Informal document No. GRB-51-12
(51st GRB, 15-17 February 2010,
Agenda item 7)

Comments of ISO/TC31/WG6 on
informal document GRB-50-7.

First argument - Rolling Resistance measurement techniques

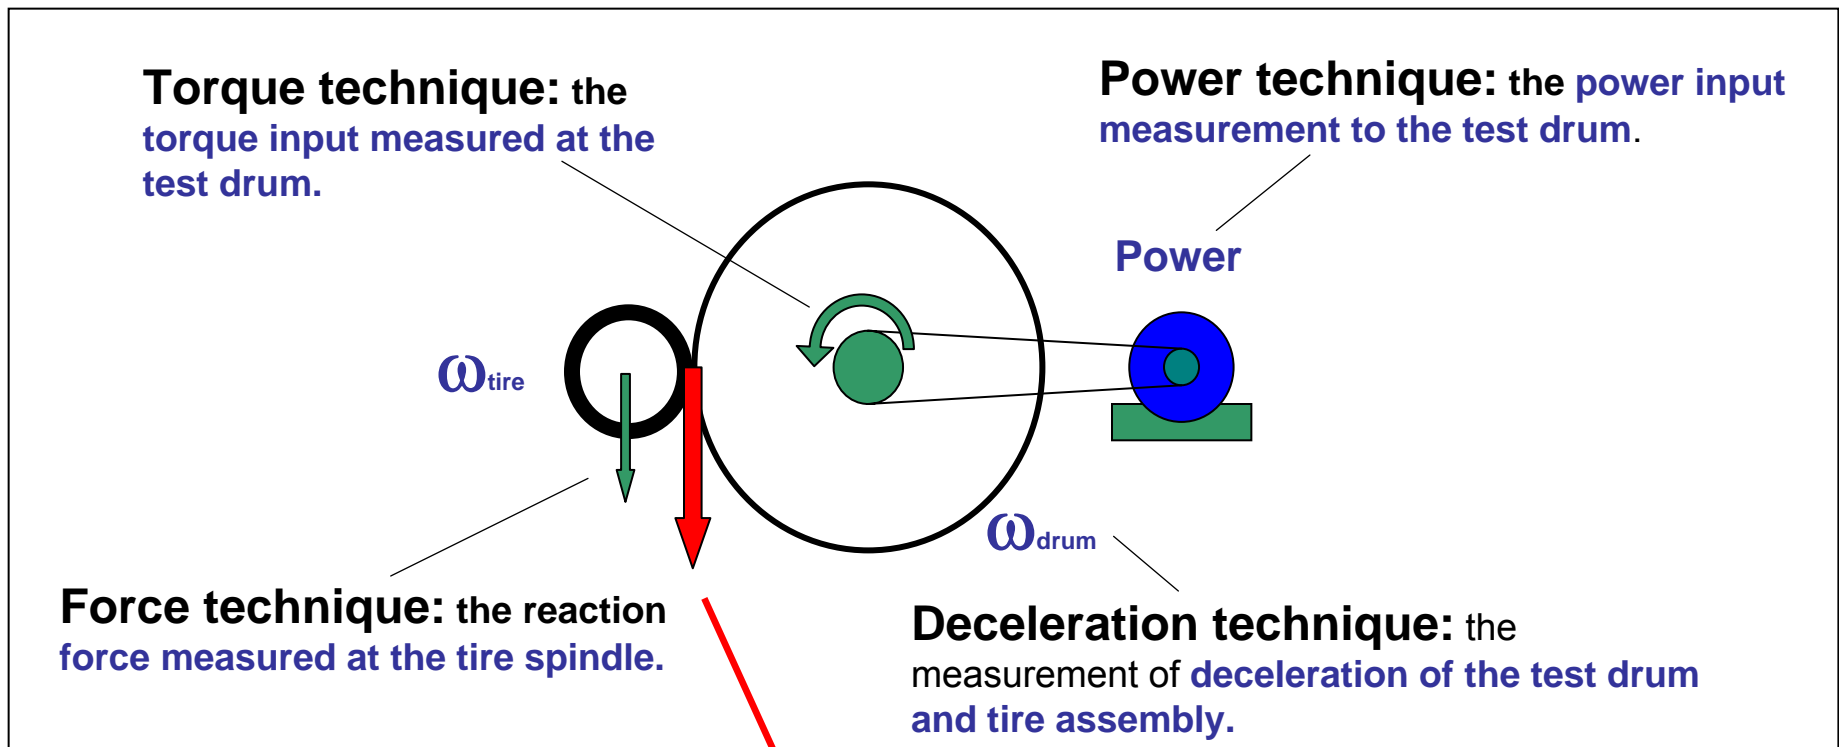
The same phenomenon is measured, at different points of the testing machine.

For each technique, the test results are converted to the force acting at the tire/drum interface, which is the tyre rolling resistance.

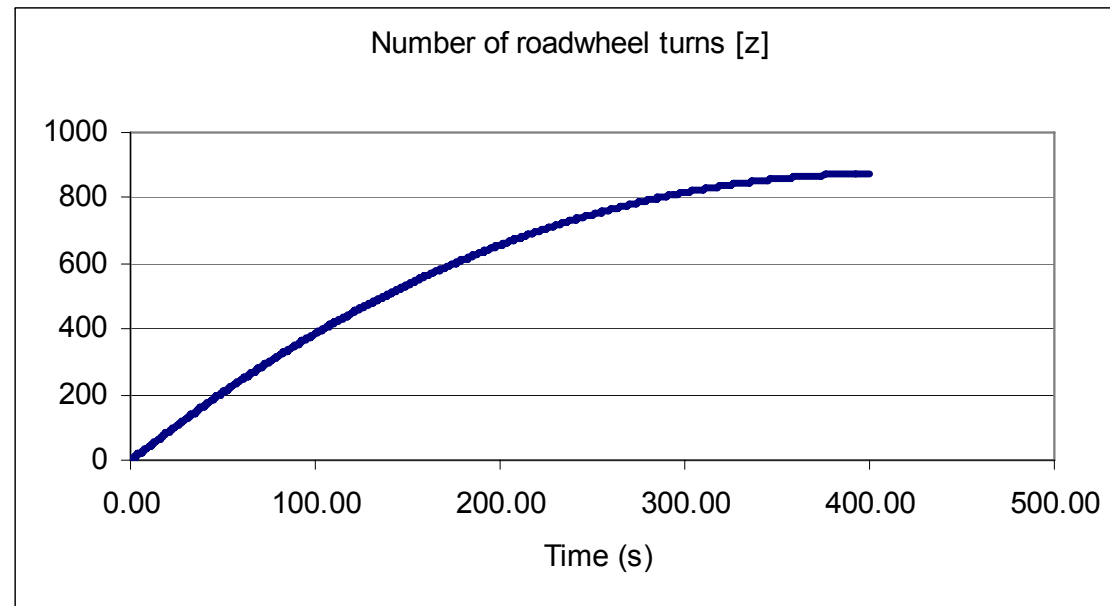
t_s and p are not defined; we assumed they stand

respectively for t_Σ and Π .
